Access Compliance Report Public Rights-of-Way (RR Crossings)

Intersection ID: 13985	Main Street: CAMDEN_RD	Location: N/A
ADA ID: 042C45C6D378	Overall Compliance: No	Severity Score: 0.0
Codes/Mitigation Info/Possible Solution		Field Measurements/Component Compliance

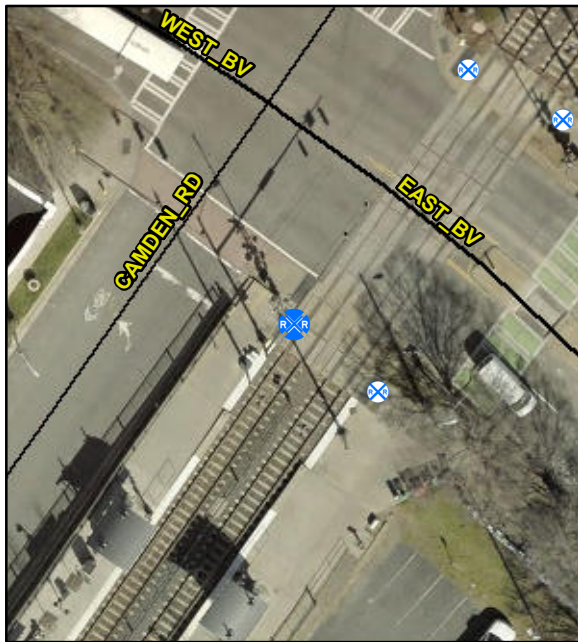
Compliance	Description	Data
Yes	DWS Provided?	Yes
Yes	DWS Contrast?	Yes
Yes	DWS Width (in)	Yes
Yes	DWS Length (in)	36.0
No	DWS Offset (in)	11.0
No	Pedestrian Gate?	No
N/A	DWS Outside Gate?	No
N/A	Rail Type?	LightRail
No	Flangeway Gap (in)	3.0
Yes	Sidewalk Width (in)	106.0

**Remove & Replace Detectable
Warning System. Provide Pedestrian
Gate. Remove & Replace Walking
Surface Adjacent to Rail.**
